**Our Ref:** P-19320

## **REQUEST FOR REZONING REVIEW - PLANNING PROPOSAL 7/20 - FIVEWAYS TRIANGLE SITE, CROWS NEST**

**RE: Planning Proposal 7/20 – Fiveways Triangle Site, Crows Nest**

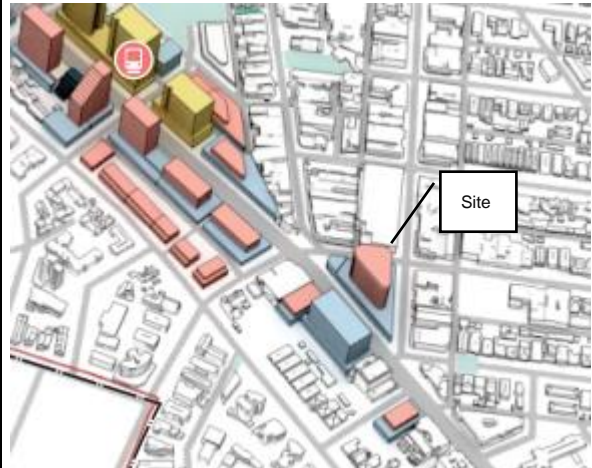
<p>The Department of Planning and Environment's (DPIE's) building massing modelling, as illustrated in SJB's Urban Design Study which underpins the accepted built form outcomes in the 2036 Plan, assumes that a 16-storey height for the site is based on a mixed-use building with a commercial podium and residential tower. This is also reflected in the Land Use and Activity Map 1 on page 51 of the SJB Urban Design Study.</p>	<p>As noted earlier, there is no such thing as an 'accepted built form outcome', instead, there are indicative built form controls with the final planning controls to be developed as part of any future rezoning process. There is also an explicit acknowledgment that there may be opportunities for specific sites to accommodate additional density [FSR] and height. It should be noted that in the draft Precinct Plan, the Fiveways Triangle site was identified as the only site in Crows Nest as being 'significant' and, therefore, capable of accommodating a taller building.</p> <p>Reproduced in Figure 1 below is the diagram taken from SJB's Urban Design Study. What is apparent from this diagram is that the Precinct Plan contemplates significant change on the Fiveways Triangle site. Whether the final building is 16 storeys or 19 storeys in height, it will be a new and prominent feature in the landscape.</p>  <p>Figure 1 - St Leonards &amp; Crows Nest 2036 Stage 02 Urban Design Study, SJB, p.36</p>
